**SUN VALLEY COMPANY
SRBA SHAPE FILE REVISION
NAIP 2009 AERIAL**

From: Clelland, Steve
Sent: Friday, May 28, 2010 3:58 PM
To: Bromley, Chris; Kelly, Vicki; Fritschle, Carter
Cc: Clelland, Steve
Subject: update on SVC - summary of numbers

Re: SRBA Subcase Nos. 37-415, 37-416, 37-22105, and 37-22106
(Sinclair Oil Corp. d/b/a Sun Valley Co.)
Revised Place of Use Map and Shapefile
MTBR&F File No. 16845.0005

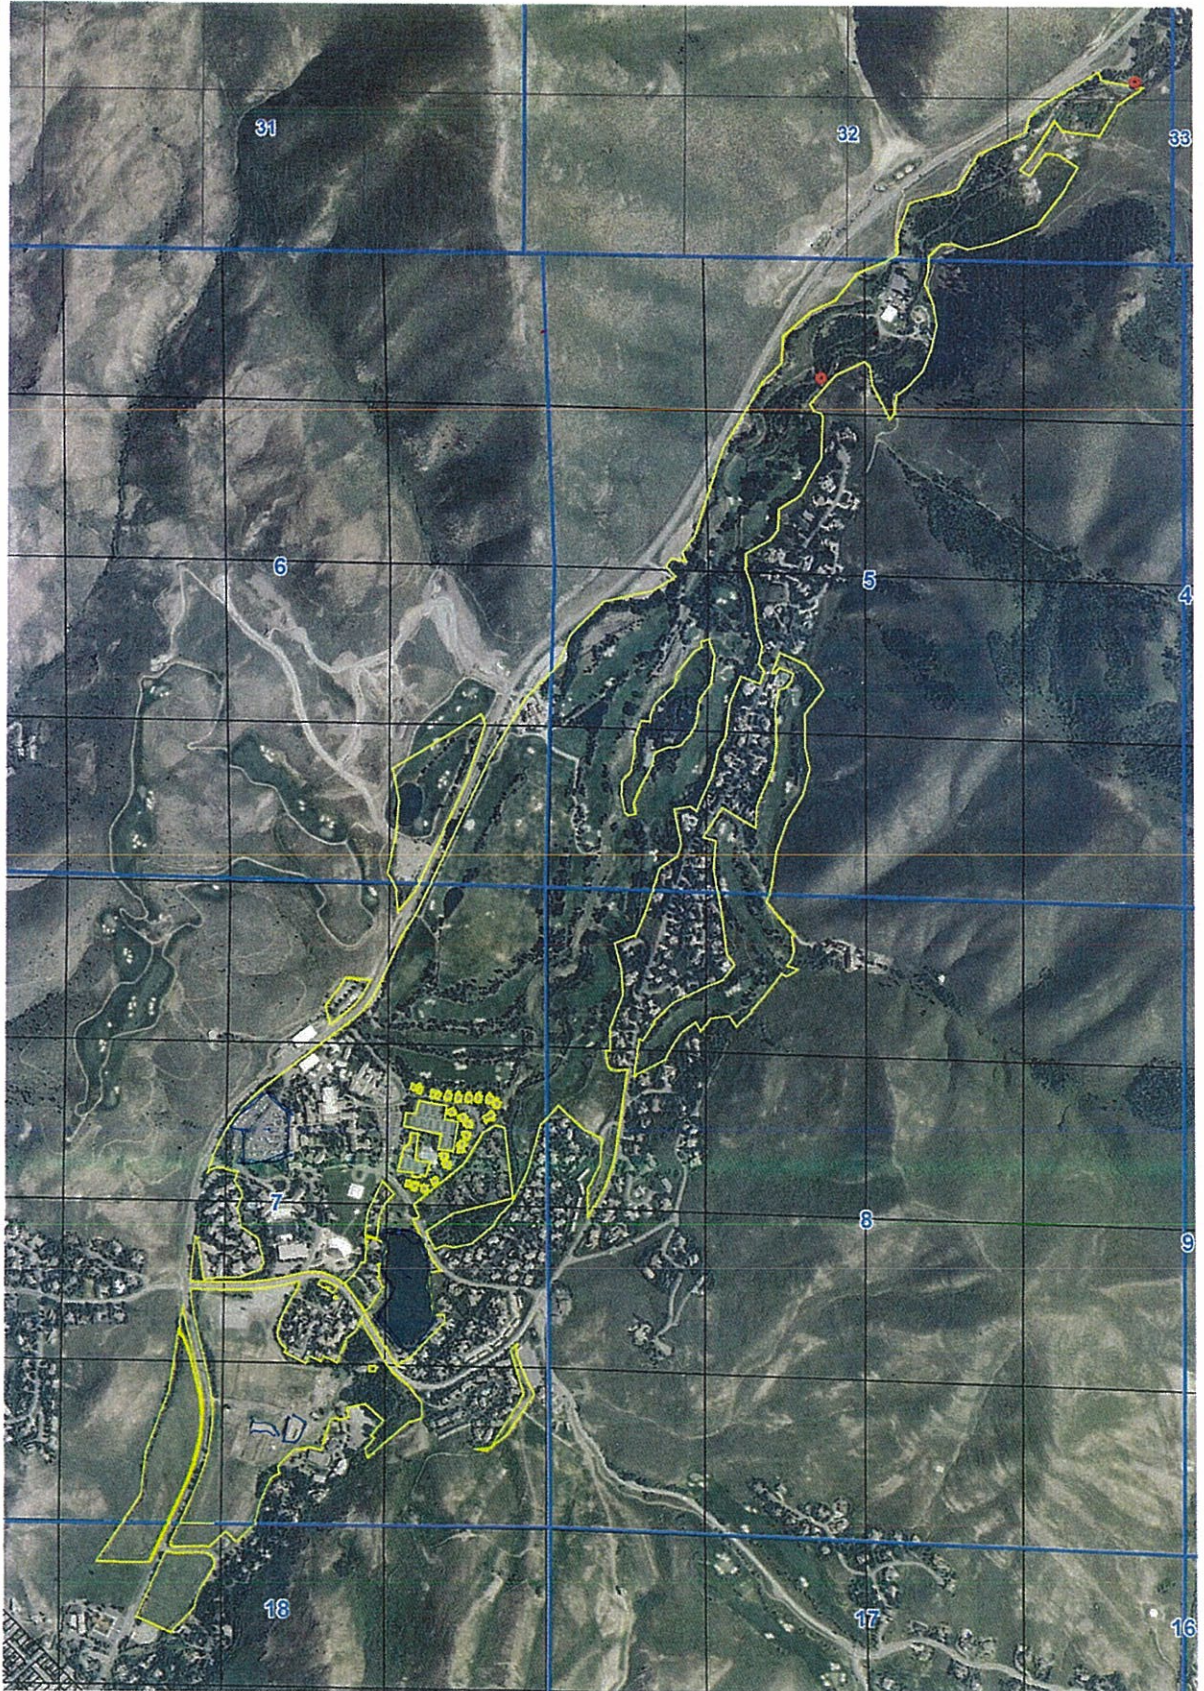
The first pdf contains 2 maps. One compares Brockway's two shapes; he has only provided two. The yellow line is his initial, post-OBJ version. It is over-layed with a red line which is his settlement offer POU shape. As you can see, he made no effort to reflect the issues Allen and I raised at our settlement meeting in Twin Falls in April. Disappointing.

COMPARES
IDWR final
Shape with
chuck's final
Shape.

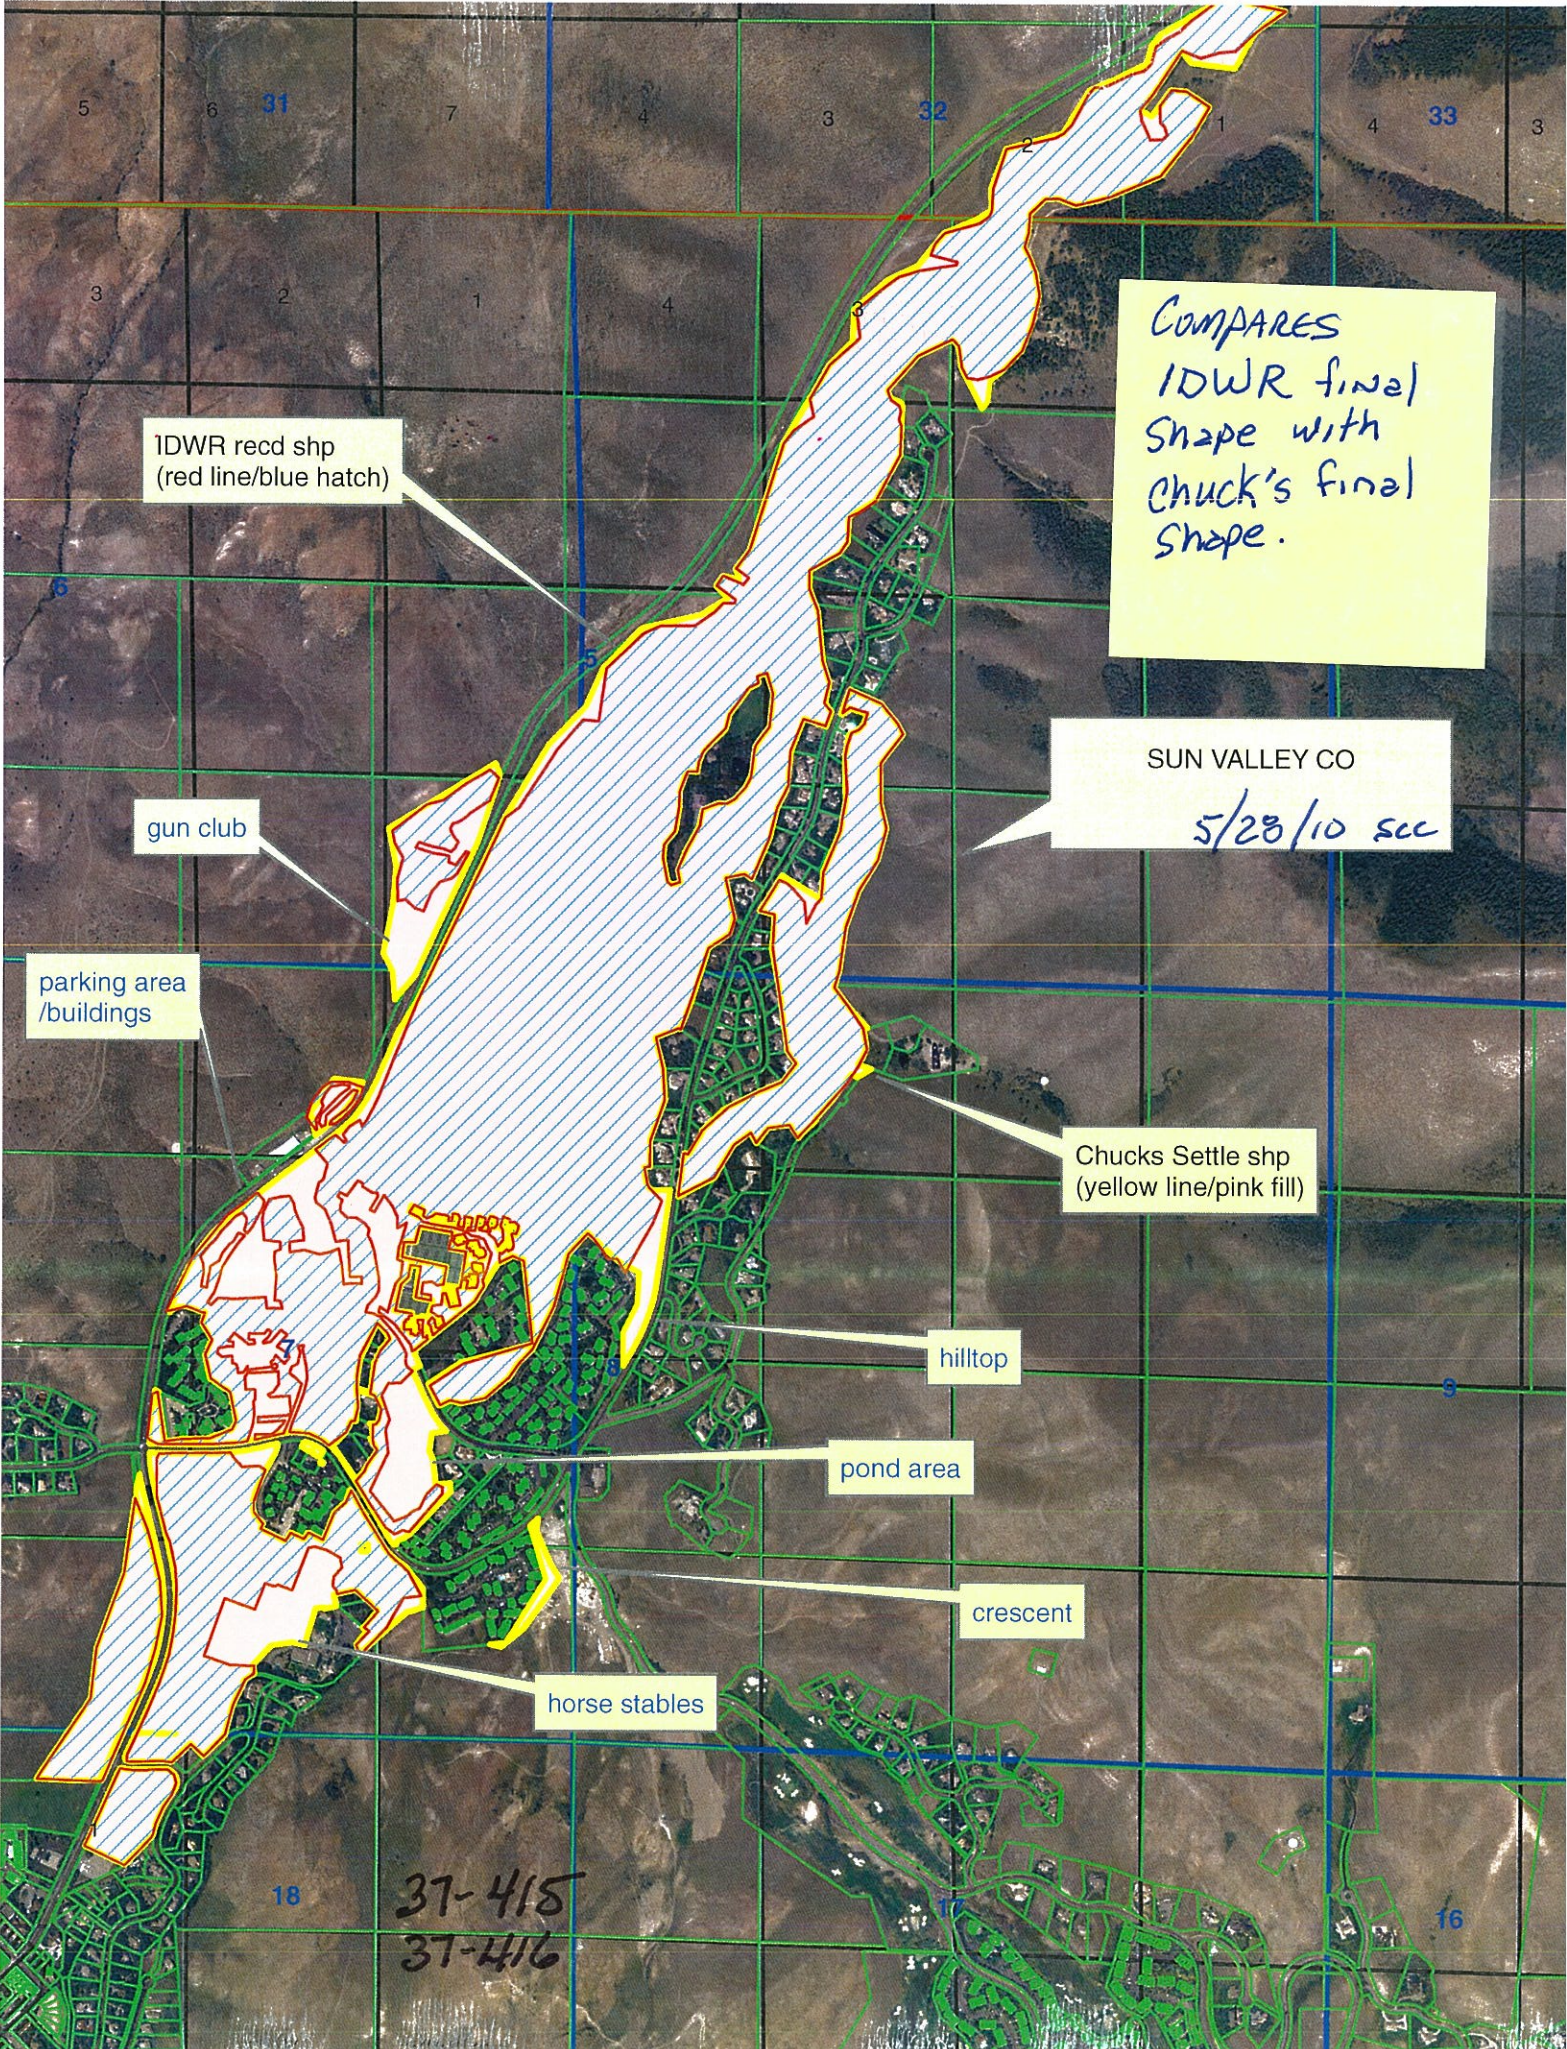
The second pdf compares Brockway's recent shape (427.7 ac.) with my final POU shape (369.5 ac.). They match closely for the most part. The main areas of variation is pointed out by the callout labels on the lower end of the POU. These are the same issues that were raised as non-irrigated lands at our TF meeting. In an effort to settle the differences between our POU acres since then I have added acres to the Hilltop site and the Horse Stable site based on aerial photos of those sites.

gun club

parking area
/buildings

hilltop

crescent

horse stables

It was discussed that perhaps we can reach settlement if we offer up the 15.4 acres shown above but hold fast to the parking lots and buildings as non-irrigated acres. If we must "draw the line" let it be here with the 369.5 acres and the current shape. Brockway has shown, with his 2 shapes, he is not interested in reaching a compromise between the shapes with IDWR. If we fail to stand with our findings it has been my experience, and based on the questions he was given (by Campbell) to ask Allen and me in TF, they are interested in showing how IDWR is continually revising our numbers. Does this illustrate we really don't have a firm grasp of the facts and data? I realize new information is gathered during review of a water right recommendation but that is not the case here.

Shape Comparison
Close-up
5/28/10

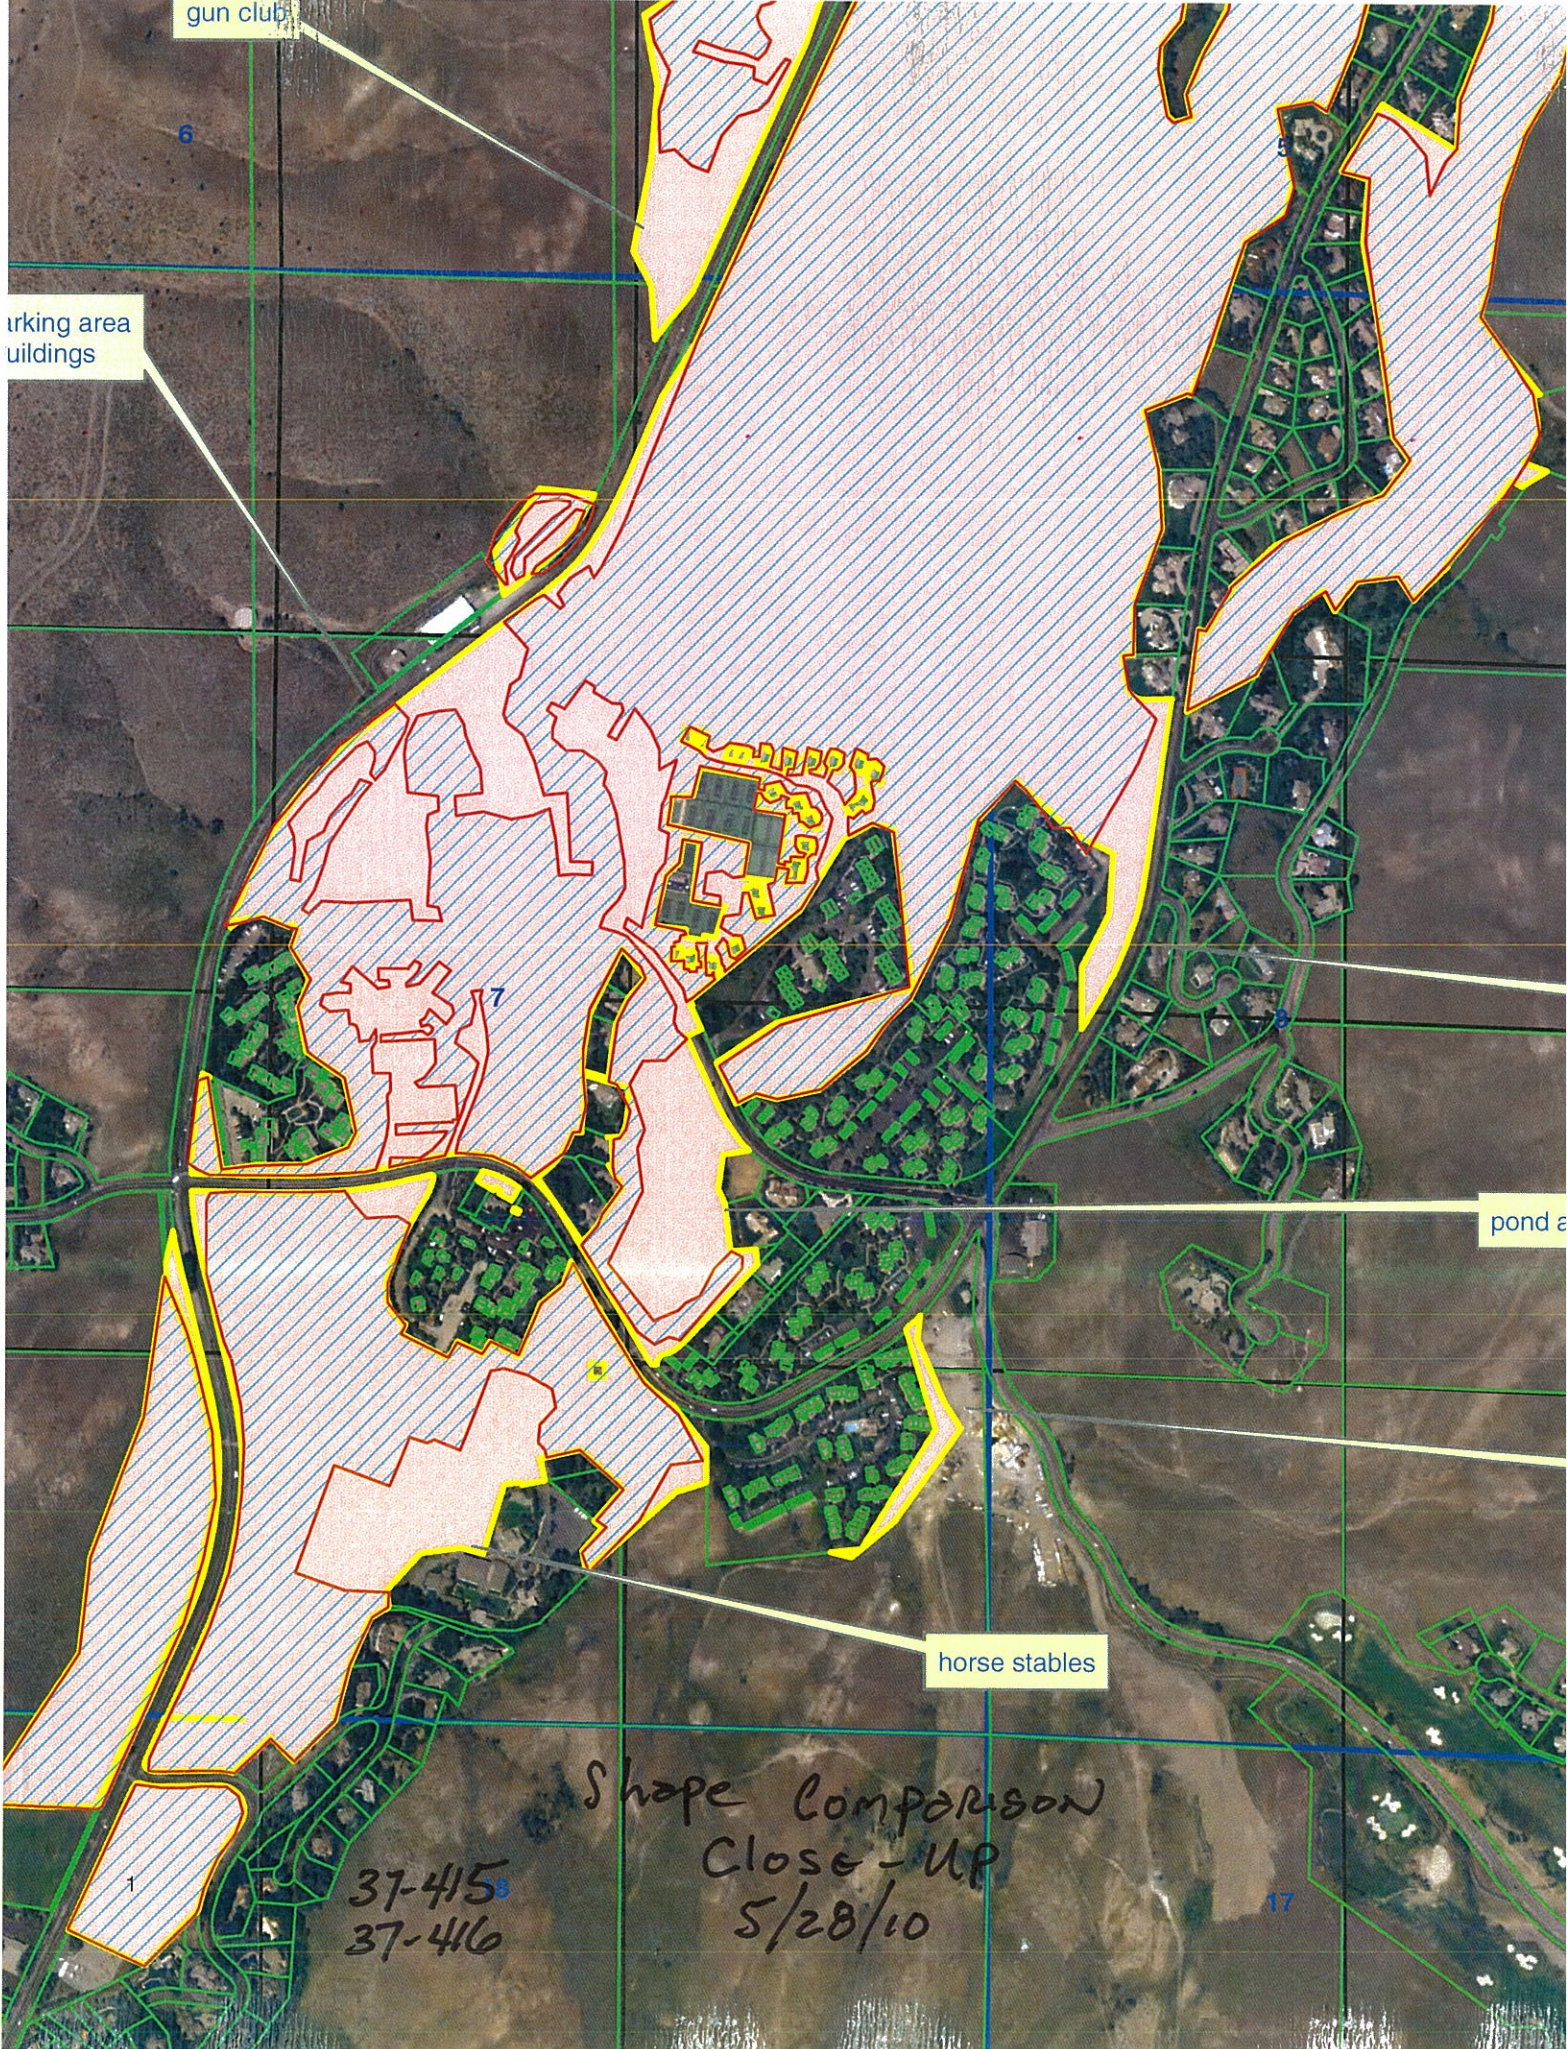
After reviewing SVC's claim 37-12111 for the Trail Creek Dam pond, I removed those 6 acres from the POU shape. Since this shape/recommendation is to be the final cut I reviewed the entire IDWR POU shape for accuracy. I removed several larger building areas near the parking lots as non-irrigated hardscape. The final pdf map shows this area in a closer view to show the details around the buildings and parking lots.

Figure 3. Irrigated areas from Trail Creek based on Sun Valley staff information and aerial photo analysis. Acreages shown exclude non-irrigated spaces such as waterways and roads.

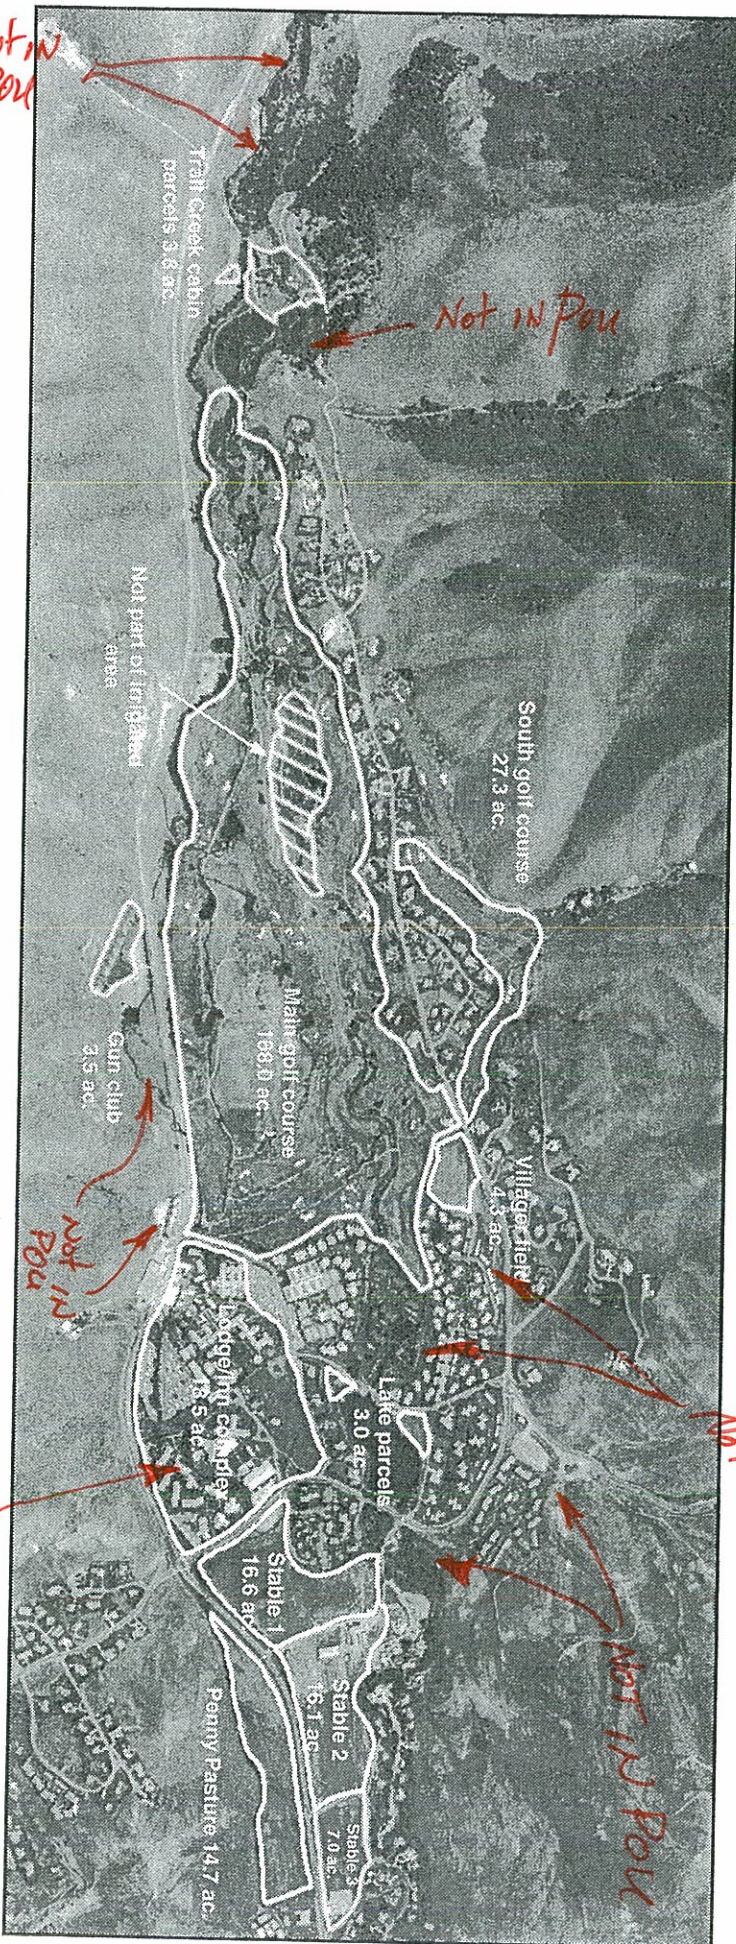
Total acres in Actual Irrigation
as shown on Fig. 3

* Brockway Acres = 1996 Report Values

- (says it does not include Non-irrigable
Hardscape.)

- Report states = potential
IRRIGATION

- "in order to irrigate all of the potentially
irrigable land, additional... modifications
to improve system efficiency would be
Required."
